Case File Number PLN21100-A01

Location:	6735 Sims Drive- See map on reverse
Assessor’s Parcel Number:	048C719302500
Proposal:	Appeal of the Zoning Manager’s Approval to allow the construction of a new single-family dwelling on a vacant, upsloping lot zoned RH-4, Hillside Residential
Applicant:	Peter David Gilbert (510) 290-0445
Owner:	Veronica Liu
Appellant:	Richard Lund c/o Patrick Nagel
Case File Number:	PLN21100-A01
Original Case File Number:	PLN21100
Planning Permits Required:	Regular Design Review to construct a new single-family dwelling on a vacant upsloping lot.
General Plan:	Hillside Residential
Zoning:	RH-4 Hillside Residential – 4 (RH-4) Zone
Environmental Determination:	Exempt pursuant to the State CEQA Guidelines: Section 15303 – New Construction of Small Structures; and 15183 – Projects Consistent with a Community Plan, General Plan, or Zoning
Historic Status:	Vacant Lot - X
City Council District:	4
Status:	The Zoning Decision Letter was mailed on March 29, 2022, and the Project was appealed on April 8, 2022.

CITY OF OAKLAND PLANNING COMMISSION

Case File: PLN21100-A01
Appellant: Patrick Nagel
Address: 6735 Sims Drive
Zone: RH-4/S-9

6735 SIMS DRIVE
PROPOSED DRIVEWAY INSTEAD OF CONNECTING SIMS DRIVE.

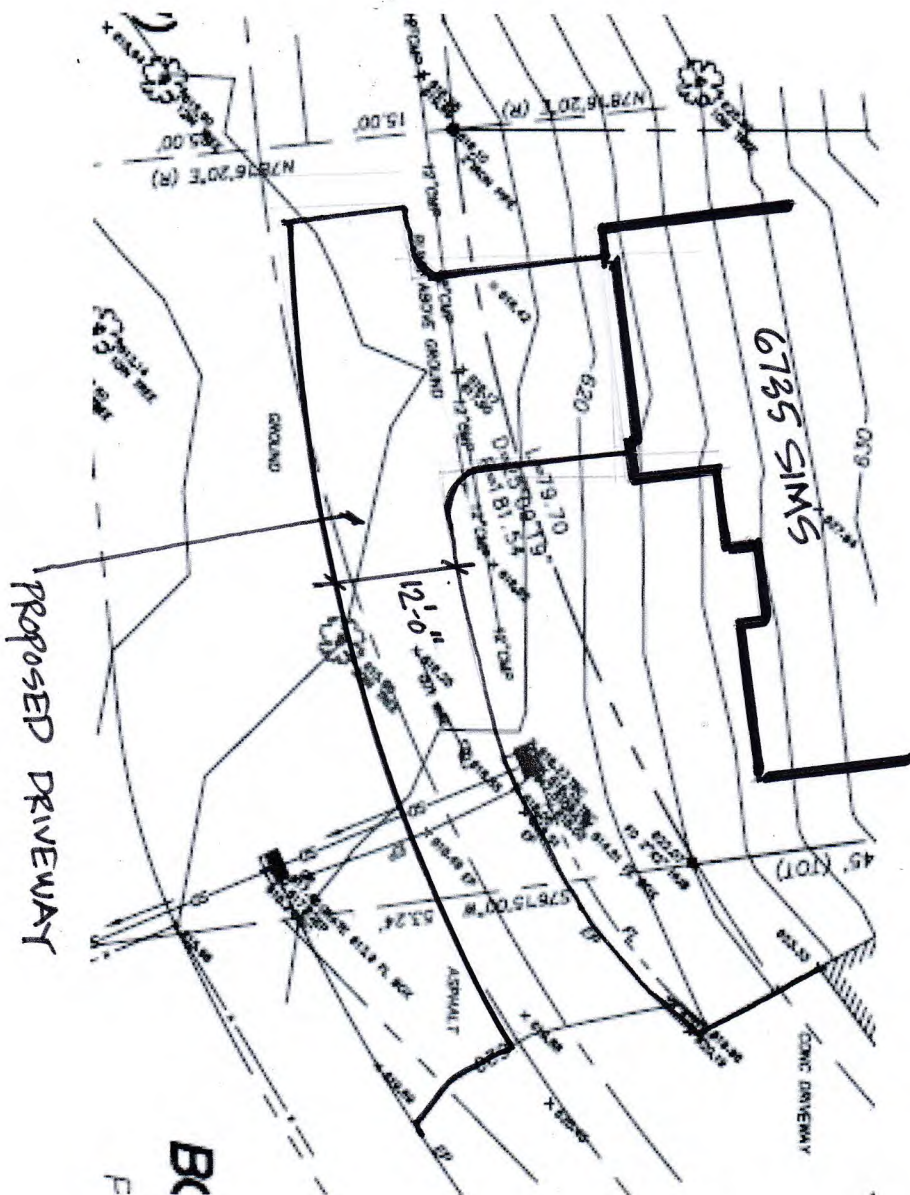
- 6. Consideration of Alternative Design for Sims Driveway- In discussions with the neighbors, the project architect prepared the alternative driveway design attached as Exhibit 5. This would provide a dead-end driveway turnaround for the subject property on Sims, without**

creating the through street connection proposed in the project approval conditions. While this change would not answer many of the other issues raised in this appeal, it would avoid the impacts associated with creating a through street on Sims Drive. This project alternative should have been considered in proper CEQA review, and considered for adoption as a condition of the project in lieu of the through street.

Staff Response
